December 11, 2020

Re: Response to December 8, 2020 Additional Information Request
Align RNG, LLC – BF Grady Road
Facility ID# 3100179
Permit No. 10644

FIGURE 1

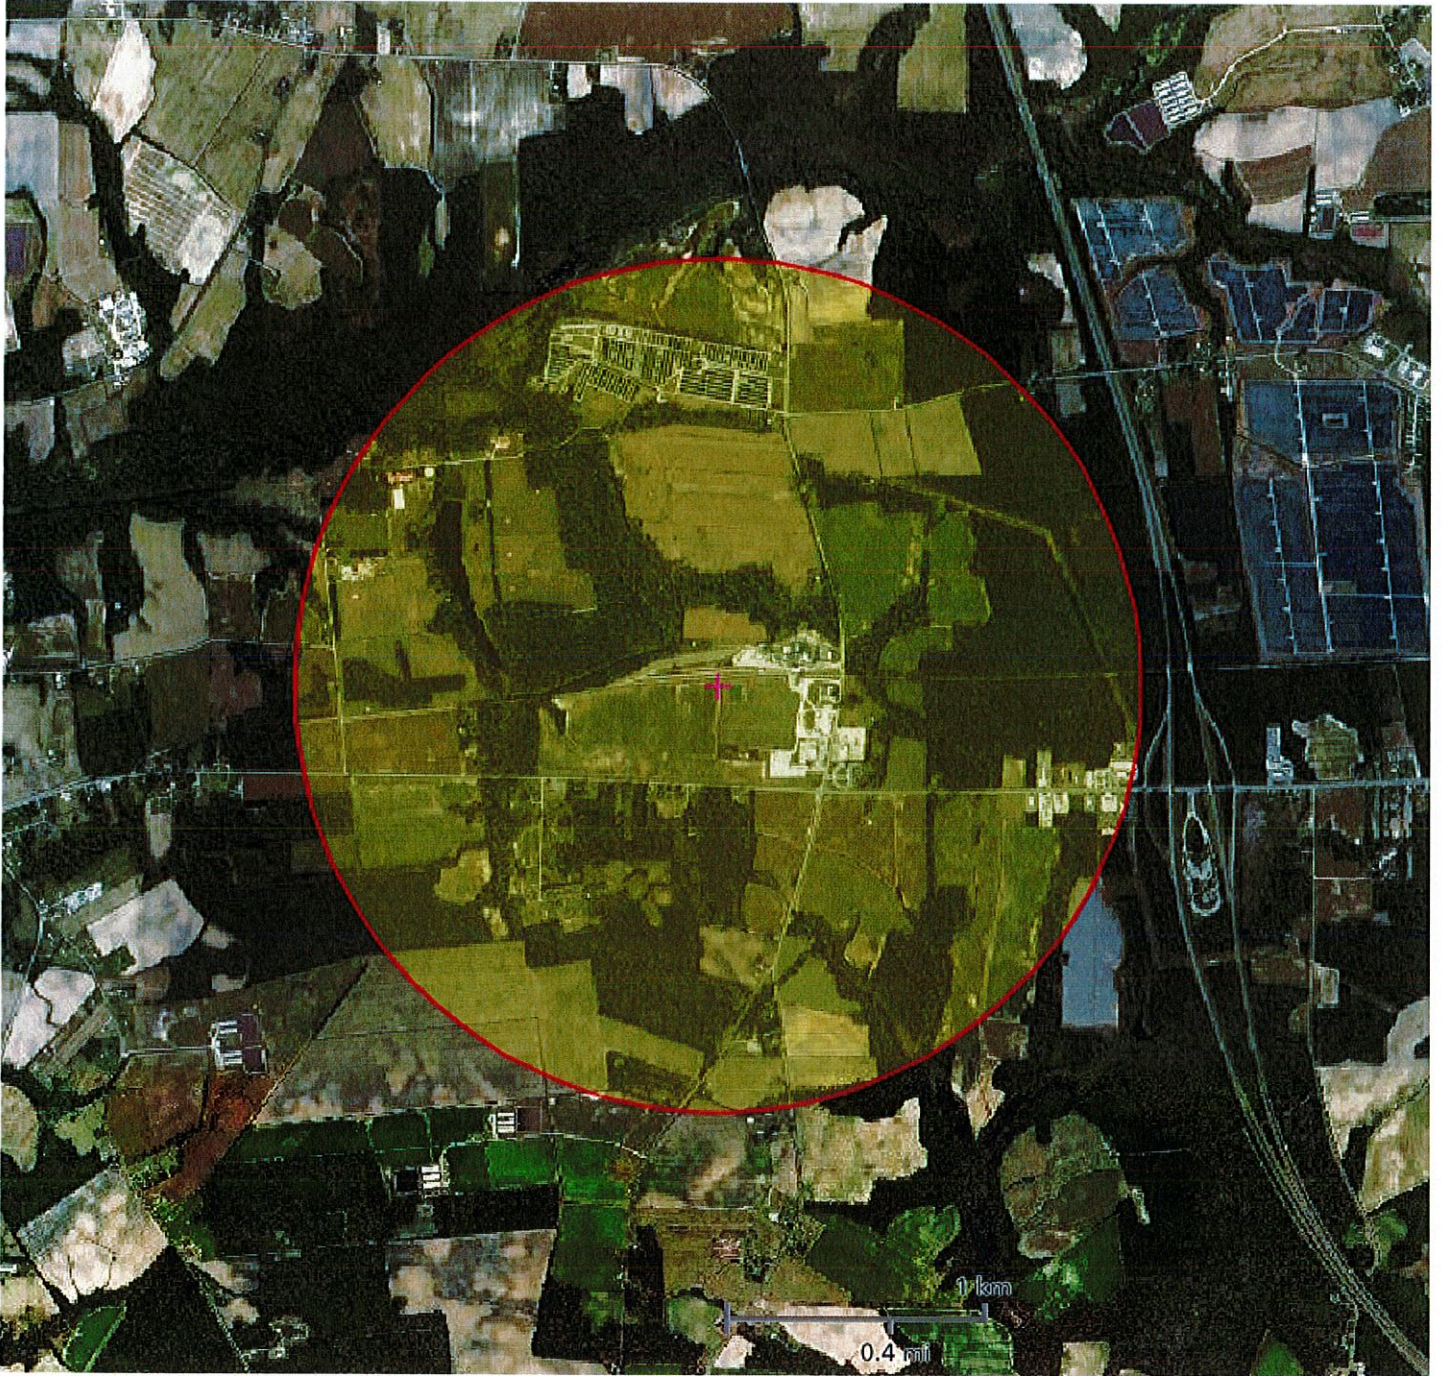
- 1. Provide the location of the 19 animal operations that will supply gas to the subject BF Grady Road facility. Please provide the physical addresses, coordinates, and a map. DEQ notes that Align has provided a representation of where the animal operations that will supply gas are located in a flyer distributed to the public earlier this year. For each animal operation, identify whether a covered lagoon or digester will be used for the production of biogas. Also, please provide the technical specifications on the type of digester that will be used at each site.**

request and in Align RNG's November 20, 2020 response to comments, there is no potential for any farm that may supply raw biogas to the BF Grady Road facility to be considered the same stationary source as the facility. As acknowledged in DEQ's September 16, 2020 Draft Permit Review (pages 1-2), the potential farms are independently owned and operated, with the closest being approximately 1.1 miles from the BF Grady Road facility. See Figure 1 attached (aerial showing no hog farms within 1 mile of BF Grady Road GUS).
